## NEBRASKA CAPITOL ENVIRONS COMMISSION STAFF REPORT

APPLICATION NUMBER Urban Design Record #24101  
APPLICATION TYPE Certificate of Appropriateness  
ADDRESS/LOCATION Downtown Corridors Streetscape Project  
HEARING DATE July 26, 2024  
ADDITIONAL MEETINGS -  
APPLICANT Hallie Salem (Urban Development), 402-441-7866, [hsalem@lincoln.ne.gov](mailto:hsalem@lincoln.ne.gov)  
STAFF CONTACT Collin Christopher, 402-441-6370, [cchristopher@lincoln.ne.gov](mailto:cchristopher@lincoln.ne.gov)

Downtown Corridors is a city-led streetscape enhancement effort meant to improve the attractiveness, safety, connectivity, and overall vibrancy of some of downtown's most important street corridors – O Street, 9th, 10th, 11th and 14th. Since January of 2022, city staff have been working with a design consultant to develop and implement a master plan for these improvements. Design for the first phase of improvements is nearing completion, and thus, the project team is seeking feedback and approval of the proposal before proceeding with construction documentation.

*Planned improvements for O Street between 14<sup>th</sup> and Centennial Mall*

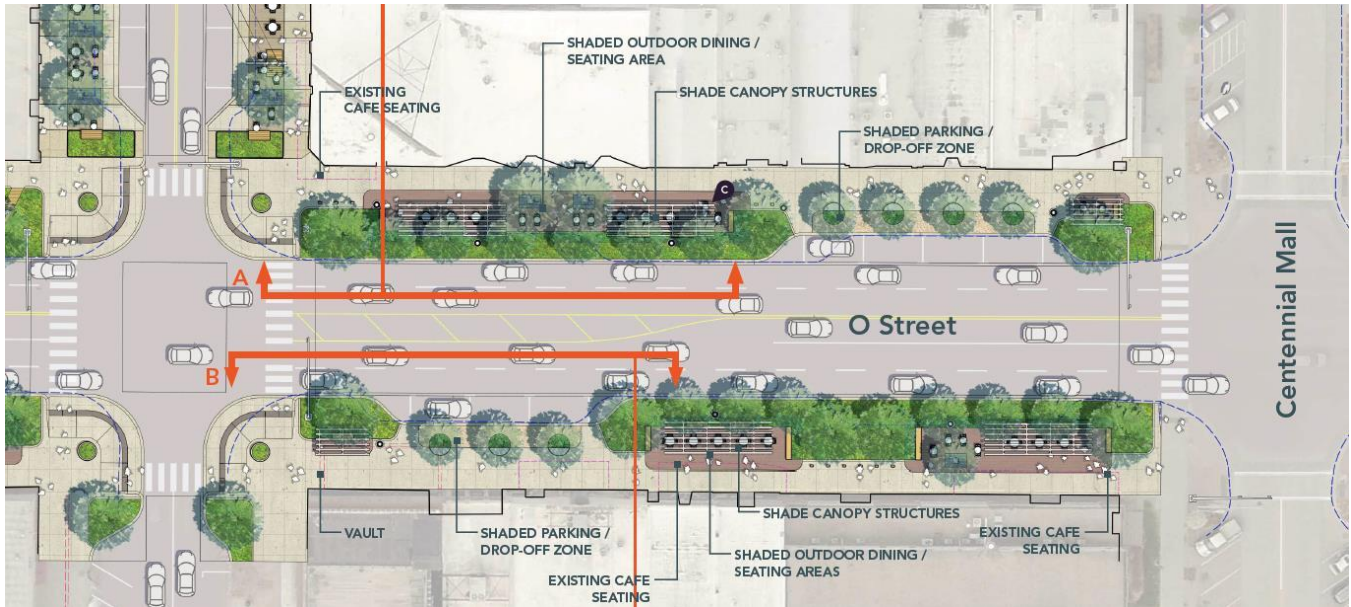
**Recommended finding:** The planned Downtown Corridors streetscape improvements within the Capitol Environs District (O Street between 14<sup>th</sup> and Centennial Mall) generally comply with the Capitol Environs Design Standards.

**Recommended action:** Approval of a Certificate of Appropriateness for the planned Downtown Corridors streetscape improvements within the Capitol Environs District (O Street between 14<sup>th</sup> and Centennial Mall).
